SOLICITATION ADDENDUM NO. 1
ITB 21-0009
Montclair Roof Replacement

DATE: October 21, 2021 382.120.003
TO: CIDA
ATTN: Dustin Johnson, Kelly Douglass
FROM: Ed Carlisle, P.E. E-mail: ecarlisle@rweng.com
SUBJECT: Montclair Gym Unit [21-0009] – Zones RFI

ROOF REPLACEMENT FOR
BSD MONTCLAIR ELEM. SCHOOL
 7250 SW VERMONT ST.
 PORTLAND, OR 97223

M5 HT'G & AIR COND'G 200
 SCALE 1/8" = 1'-0"

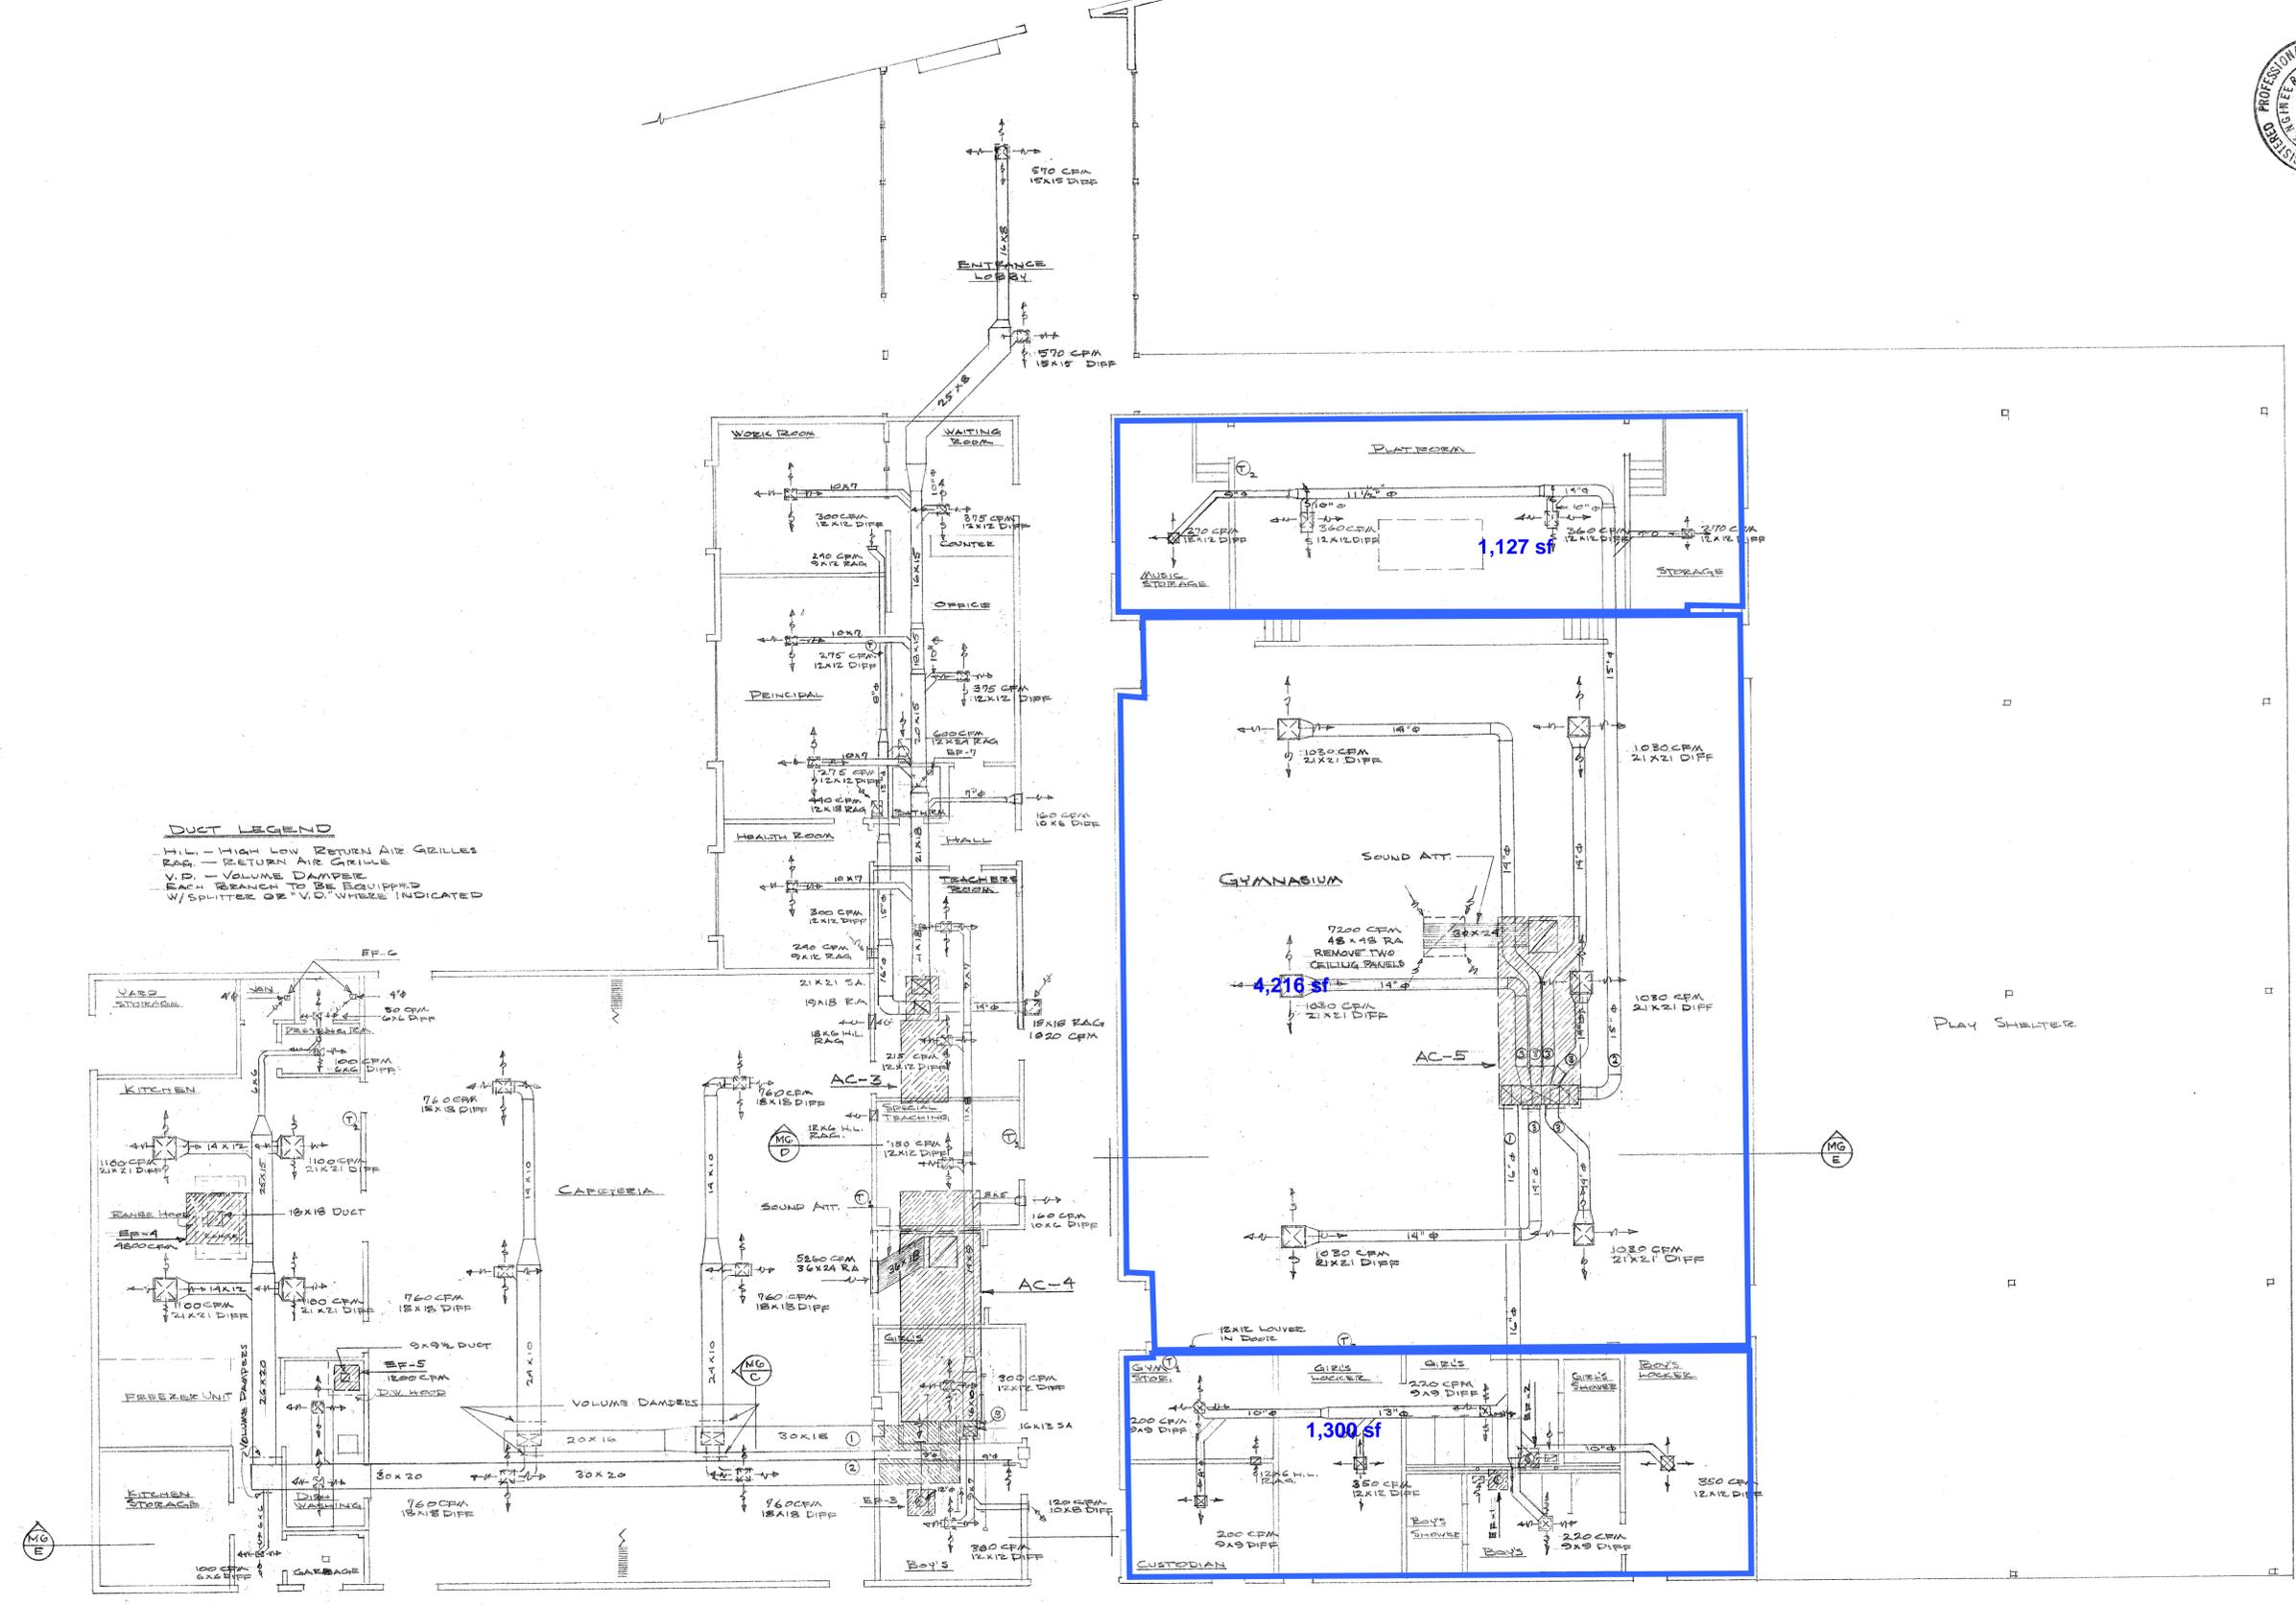
“How many zone dampers are there on the existing unit, and what are the sizes of the zones?”

Per the BSD archived drawing set dated 1969, sheet M5 (“HTG & AIR COND’G” [sic]) shows the gym unit AC-5 as covering three zones in the gymnasium area: the gym floor, the stage and adjacent storage rooms, and the locker/shower rooms (boys/girls, as well as custodian and storage rooms).

- 1) Gym stage and storage rooms- 1,130 sq ft.
- 2) Main gymnasium floor – 4,220 sq ft.
- 3) Locker/shower rooms, custodian, and storage – 1,300 sq ft.

See attached PDF “Page M5...” for zone outlines and area takeoffs.

AD1.1 DEMO ROOF PLAN
 1/16" = 1'-0"

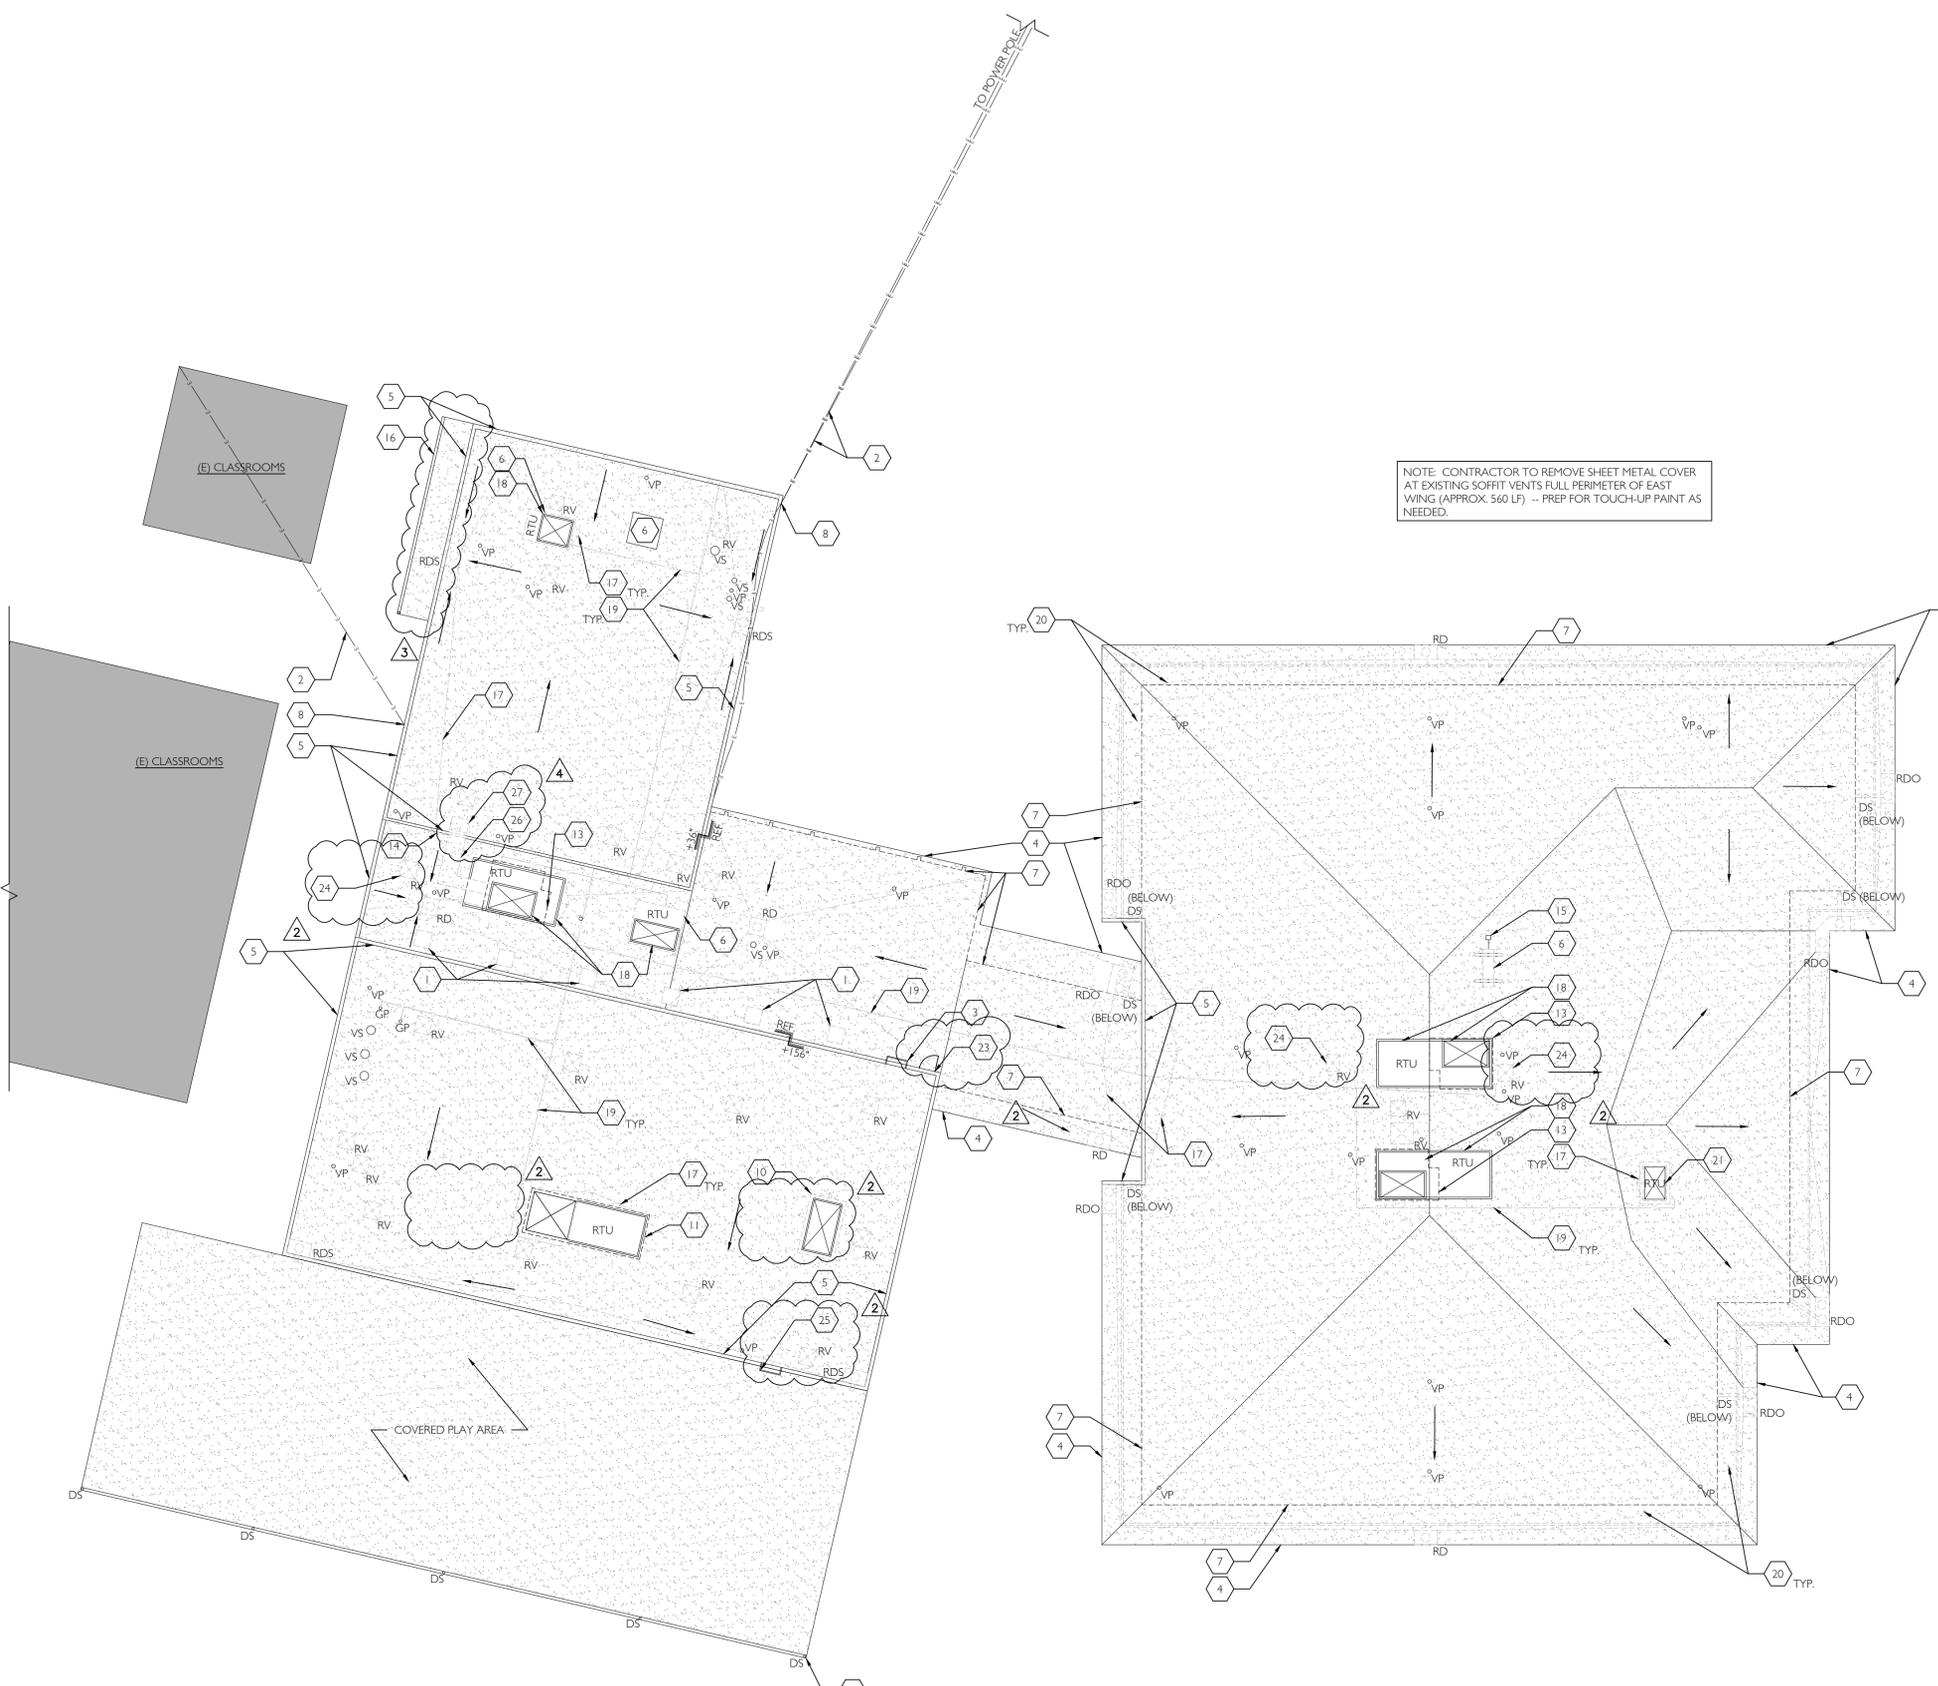
- Sheet AD1.1: Keynote 11 revised to indicate gym RTU to be *temporarily* removed. Keynotes 26 and 27 added to address demo work at existing sidewall penetration.
- Sheet A1.1: Keynote 24 added to address duct re-route. Keynote 9 revised to incorporate Add Alt #1.
- Sheet A3.2: Detail 7/A3.2 was correct to show field TPO membrane.
- Sheet M1.1: Duct re-route at sidewall penetration indicated. Sheet Note 1 revised to incorporate Add Alt #1.
- Sheet M1.2: Details 4 & 5 added to address duct re-route at sidewall.

- (E) ROOF TOP UNIT TO BE TEMPORARILY REMOVED -- RAISE CURB AS NEEDED TO ACCOMMODATE DEPTH OF NEW INSULATION.
- NOT USED
- (E) ROOFTOP MECH. UNIT TO REMAIN IN PLACE DURING RE-ROOF

- (E) SHEET METAL CAP AT ABANDONED SIDEWALL PENETRATION TO BE REMOVED-- PREP OPENING FOR INFILL
- (E) PITCH POCKET TO BE REMOVED AND REPLACED.
- (E) CANOPY BELOW

- REMOVE EXISTING ELECTRICAL BOX CONNECTED TO EQUIPMENT CURB -- SEE A1.1 FOR MORE INFO.
- (E) FIXED LADDER TO REMAIN
- (E) DUCT TO BE REMOVED AND REROUTED -- PREP SIDEWALL PENETRATION FOR INFILL
